Remarks

VI. Amendments to the Drawings and Specification

Amendments to the Drawings:

FIG. 1

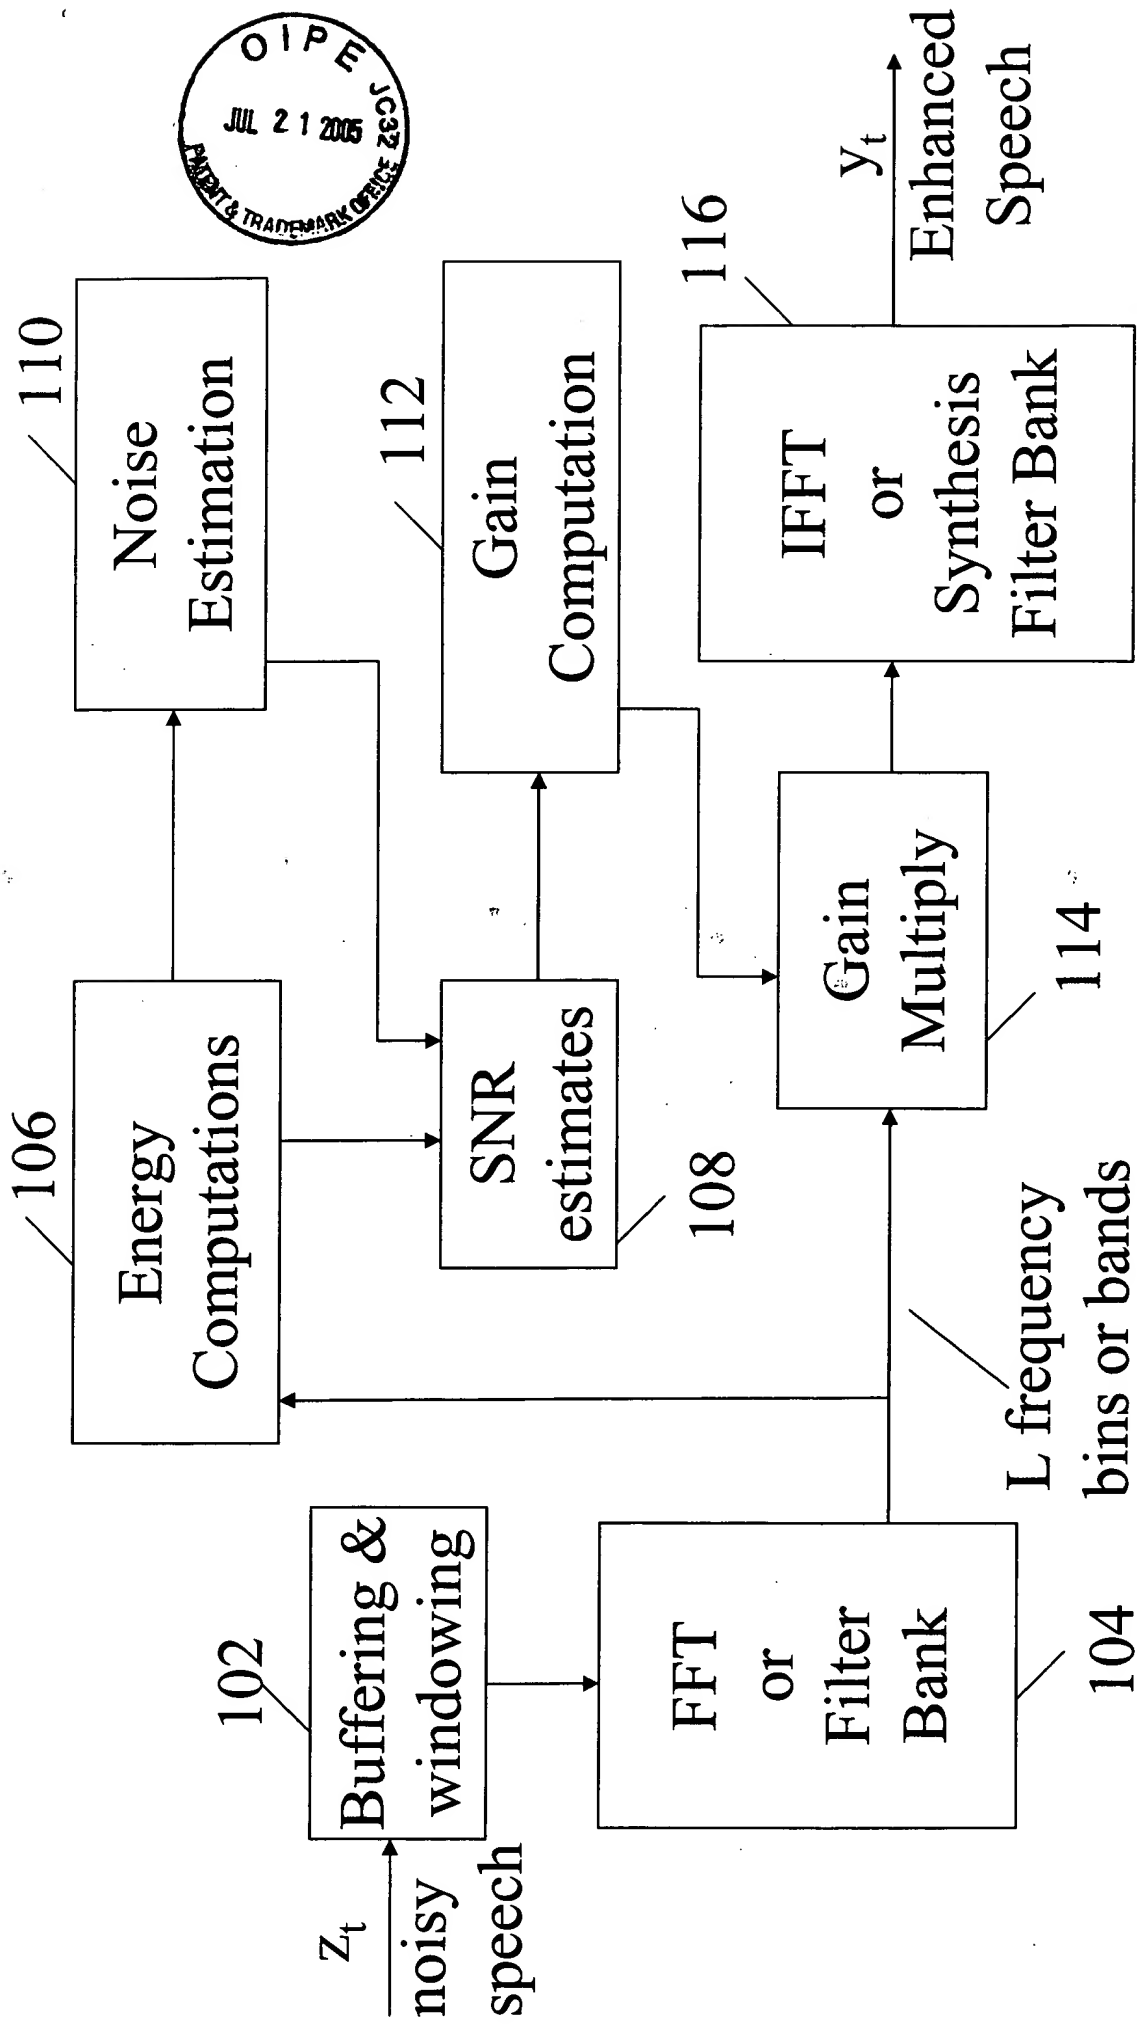
With respect to Figure 1, the Examiner stated that the recitation of "Related Art" should read "Prior Art" instead. In response, applicant has amended Figure 1 to read "Prior Art."

PRIOR
~~RELATED~~ ART

FIG. 3

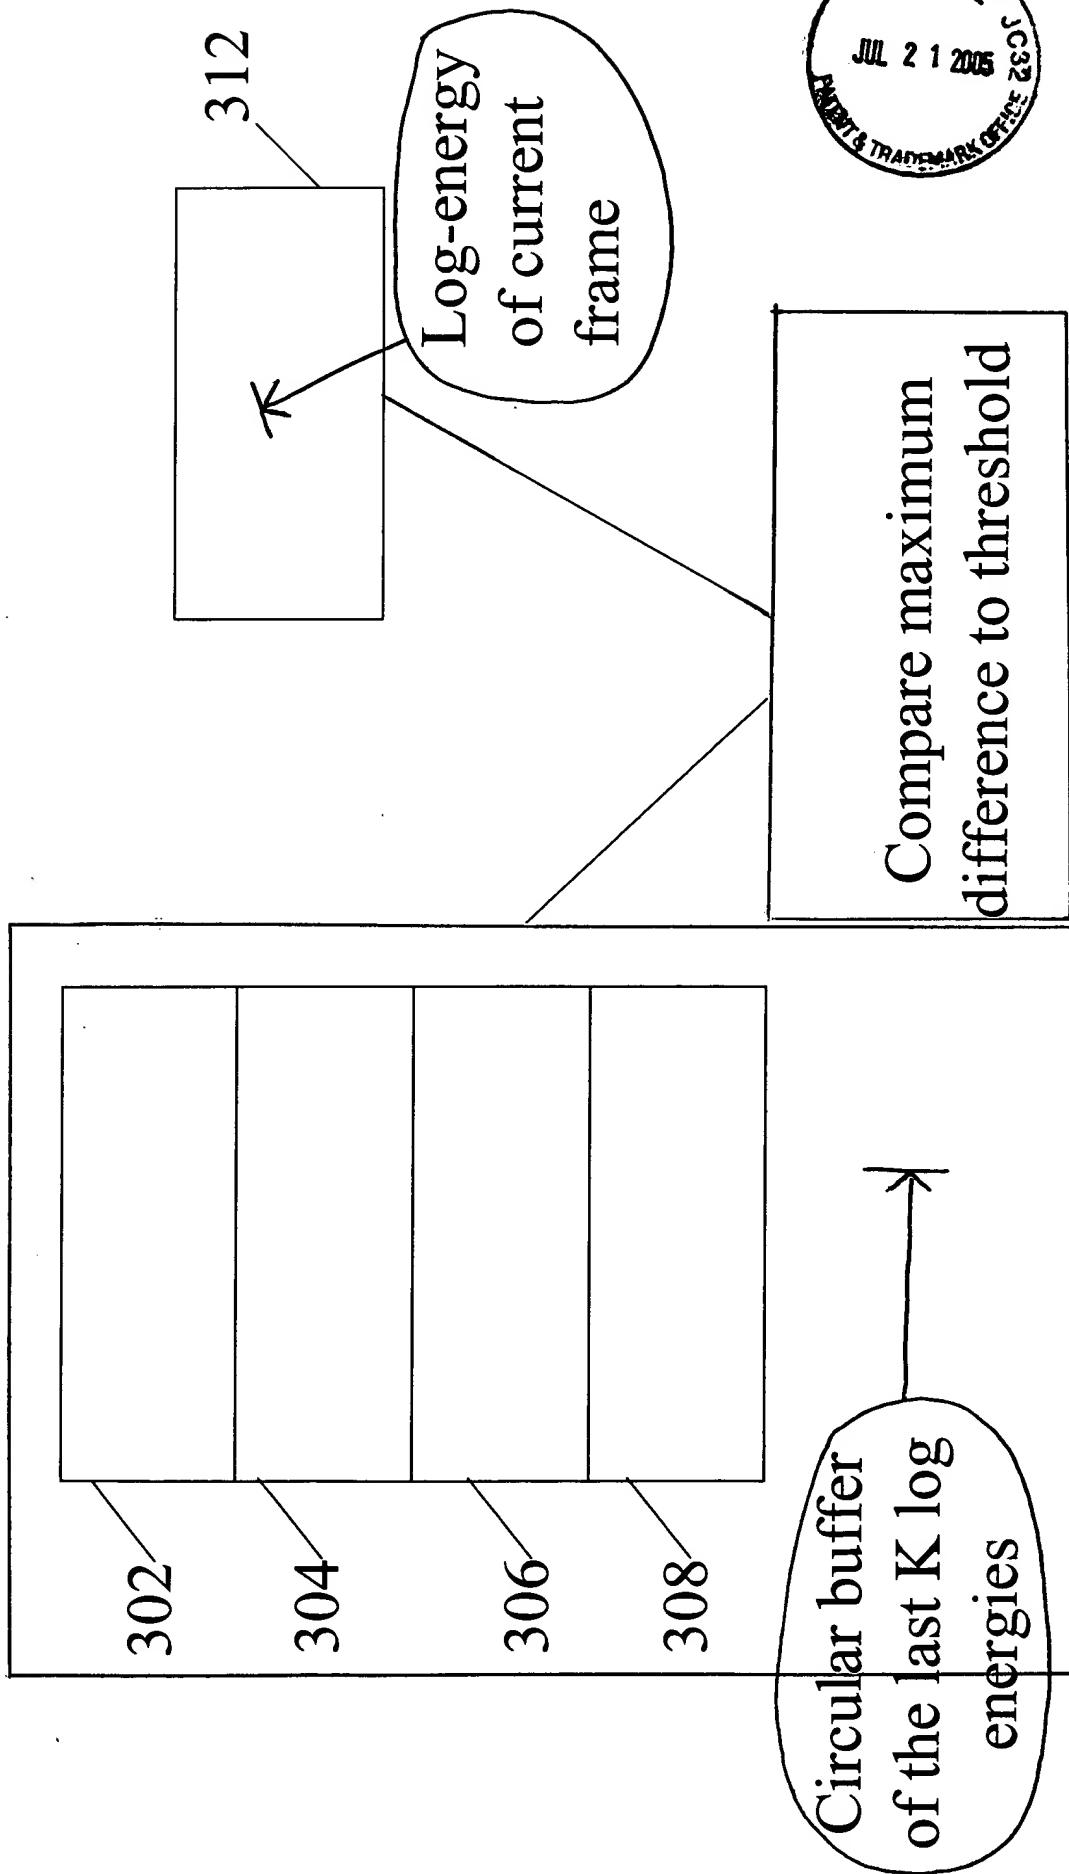
With respect to Figure 3, the Examiner noted that "[n]o reference is made in the specification to the blocks numbered in figure 3 nor do the blocks have descriptions or abbreviations inside them. The extraneous text of figure 3 should be placed in appropriate blocks or removed. It is unclear what relationship exists between blocks 302, 304, 306, 308 and 312 because no indication of data flow or input/output is evident. Two lines fail to interconnect or show direction of data flow between any elements of figure 3."

In response, applicant has amended the specification to make reference to blocks 302-312. Particularly, the specification has been amended to recite “[t]he difference of the log frame energy is equivalent to determining the ratio of the energy between the current frame 312 and each of the last K frames 302, 304, 306 and 308.” No new matter has been added. Additionally, applicant has amended Figure 3 to place the text inside appropriate boxes. The lead lines have been connected to these boxes to show that the maximum difference between energies 302-310 and 312 is compared to a threshold, as described in the corresponding description of Figure 3 in the specification (see p. 11, l. 15 to p. 12, l. 7 of applicant’s specification).

FIG. 5

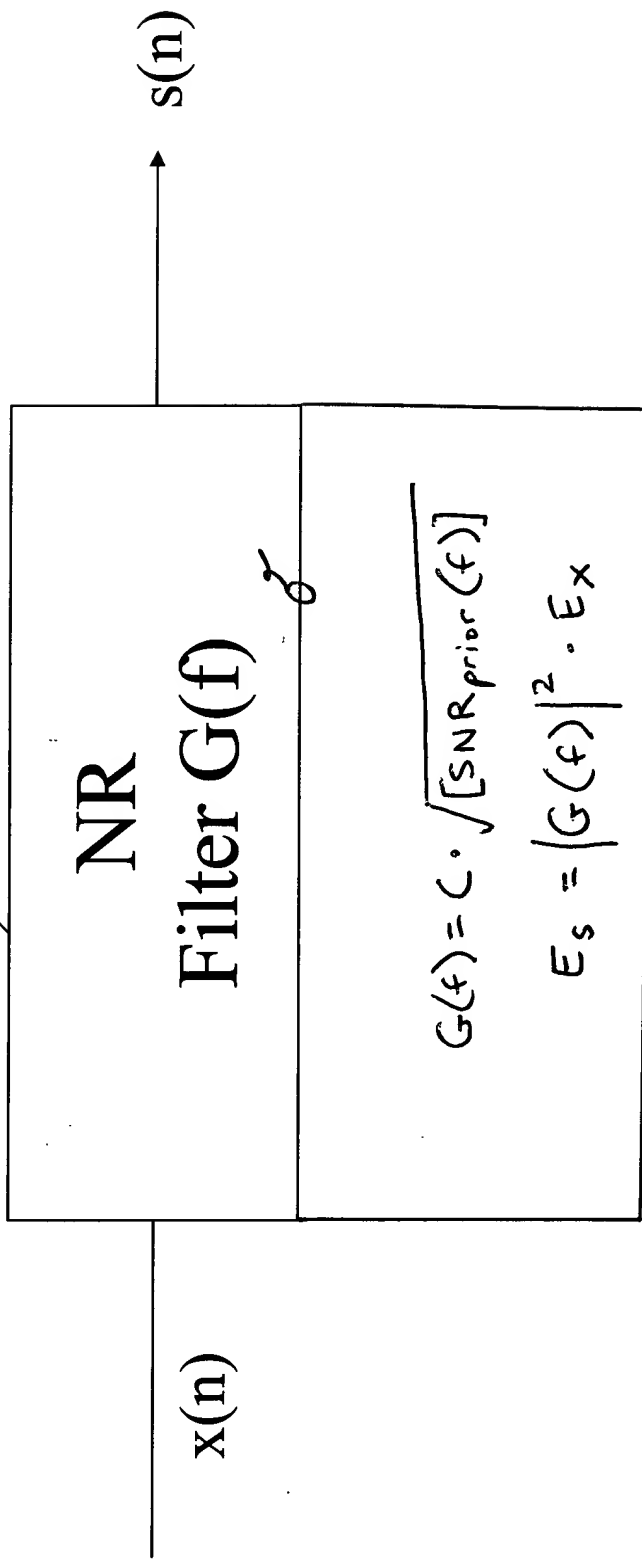
With respect to Figure 5, the Examiner stated that “Figure 5 is objected to as a ‘black box’ depiction which fails to show any meaningful processing. The details contained within block 502 should be shown to give this element significant meaning or the figure should be labeled as ‘prior art’.” In response, applicant has amended Figure 5 to show the description of the filter gain $G(f)$ described in the specification (p. 18, ll. 1-9), and to show the relation described in the specification between the input and output energies of the speech bands as a function of the filter gain $G(f)$ (p. 19, ll. 7-10).
